April 20, 2023

Subject: Northwestern University Ryan Field
Environmental Assessment Review and Summary

Figure 1: Time History of LeqA Values during Game Day Activities (October 7-10, 2022)

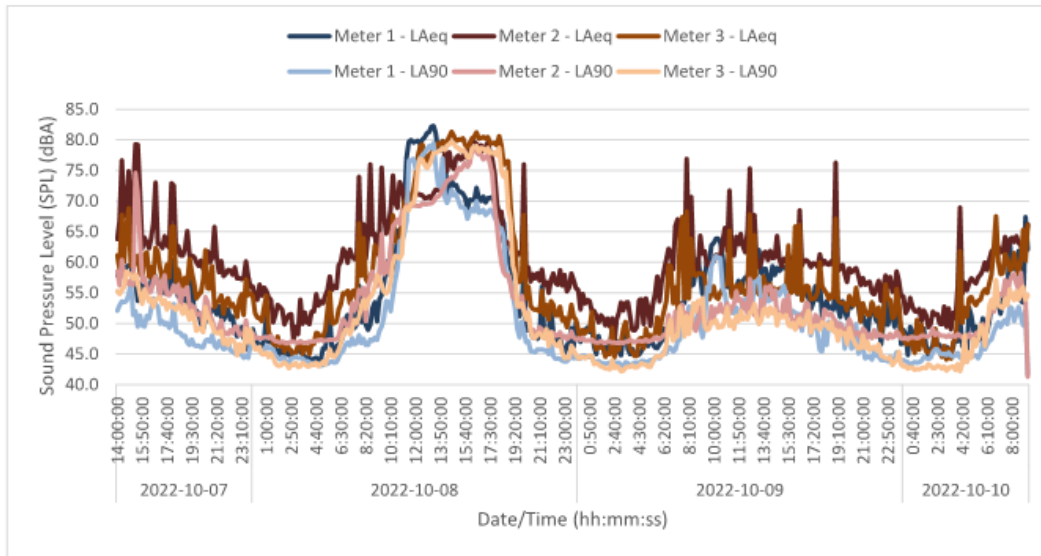
A review of the measured sound data during the game day weekend at the existing stadium shows an increase in sound levels on Saturday, October 8, during the time the football game and associated activities would occur. By reviewing the graph, it is showing sound levels begin increasing rapidly around 9-10 am and continue through game time before subsiding around 6pm. The levels on Saturday are higher than the Sunday, October 9, sound levels and are indicative of the sound generated at the stadium compared to typical ambient sound. Further, the sound measurements taken during a non-game day weekend confirm the typical ambient sound levels in the area are consistently lower than the measured pre-game/game activity at the existing stadium. It is shown in these figures that the current weekend daytime ambient sound levels are around 60-65 dBA, and that game day activities increase

these sound levels up to 70-80 dBA, notably for a period of time that extends beyond just the football game itself.

It should be noted the sound monitoring positions during game day measurements were located on the Ryan Field/Northwestern University property and were identified as tailgating activities, music in the parking lot(s), and large crowds. As the measurement locations are essentially “within” the sound source, these are considered the highest sound levels in the area. Sound level will diminish at some rate as it moves into the residential communities meaning the actual stadium sound impact may be less in the neighborhoods as compared to what was measured in the parking lots.

Figure 3: Concert Environmental Assessment Results

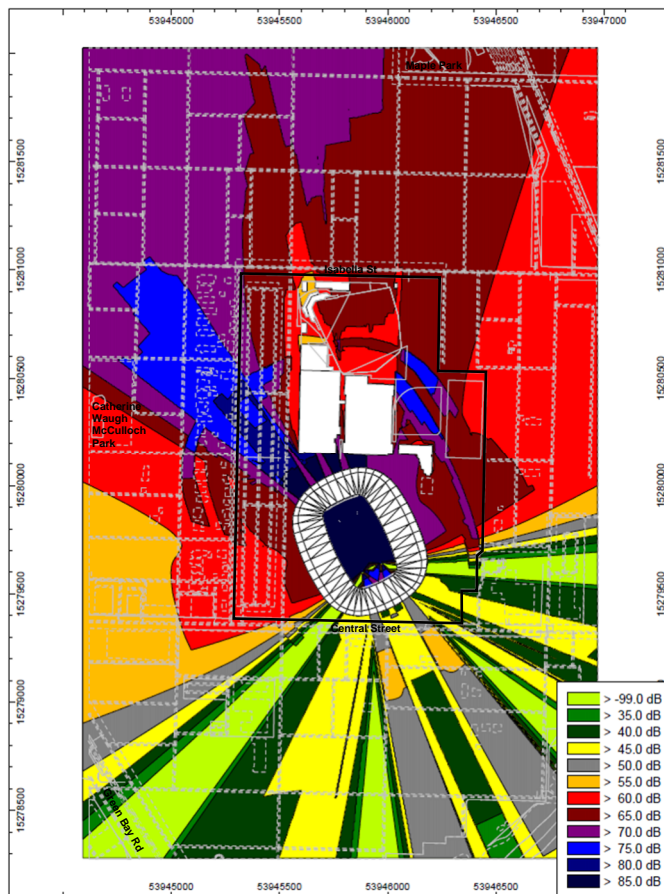
The results of this analysis show sound generated at the new stadium is projected to the north and west. Areas to the east and south also show sound impact, but less so than to the north. Sound transmission to the south could be described as noticeable but generally does not substantially exceed the ambient sound levels measured in the area. Alternative stage locations do not appear to be an attractive option for sound mitigation, given the sound reduction benefits of the building barrier effect related to Welsh-Ryan Arena and other existing Northwestern structures. That is, the existing structures help block/shield transmission to the north residential properties; there is no such barrier at the south of the property to provide the same barrier effect to those southern residences.

Predicted sound levels are approximately 55-75 dBA and reach similar peak levels to those measured for game day activities at the existing stadium. Levels associated with concerts, while elevated, are expected to occur for shorter aggregate periods of time than football game day activities, though they may be more consistent during that period. We estimate the typical concert to be approximately 3-4 hours (doors open to end of encore), less than the 6-8 hours observed for game day events.

Projected concert sound levels were evaluated at the surrounding property lines. The Henderson model accounts for disruption to sound patterns caused by University-owned structures (such as impact seen in the graphic above), but does not account for the impact of non-University owned property. Therefore, the model doesn't account for the impact of residential buildings or other structures, which would limit

how far into the residential area sound travels before it reaches ambient levels. The sound levels in the residential community will be lower than at the property line, when factoring in the impact of other structures, distance, directivity, and other factors.

The Henderson model results shown above does not account for any additional sound mitigation efforts beyond the two design features noted above.

Figure 4: Concert Environmental Assessment Results with Additional Sound Mitigation

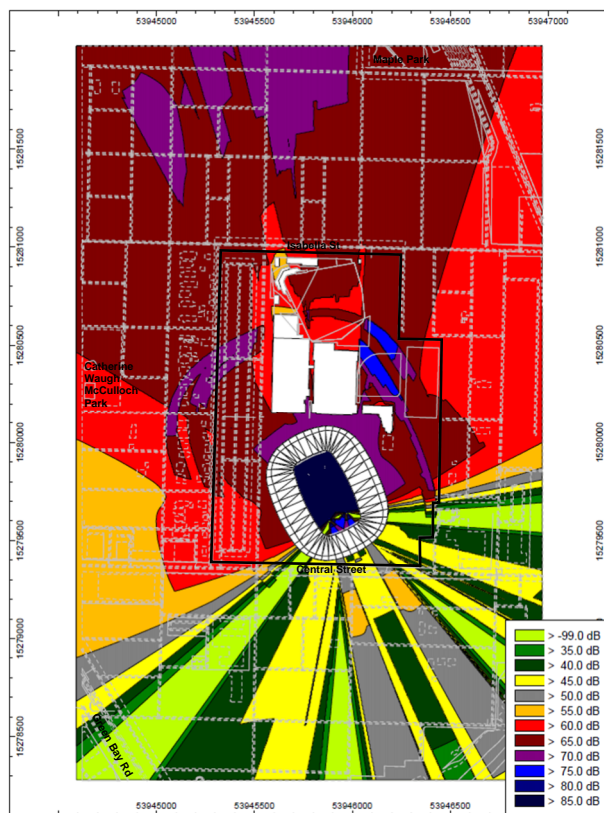
With additional effective mitigations, there is a noticeable reduction in sound impact on the immediate West property line, and a noticeable reduction in sound impact to the Northwest. While sound will still be audible, projections generally fall in the 60 and 65 dBA ranges. There is a small sound shadow impact to the north that would positively impact a small number of residents. Again, this model does not account for the beneficial sound reduction impact that would be generated by the residential houses at the property lines.

Additional modeling is required to determine the exact extent of the barriers and the necessary sound reduction qualities of the materials installed, but our recommendation is that Northwestern consider including this mitigation in the project, or have the opportunity to add them at a later time as an additional mechanism to mitigate environmental sound transmission.
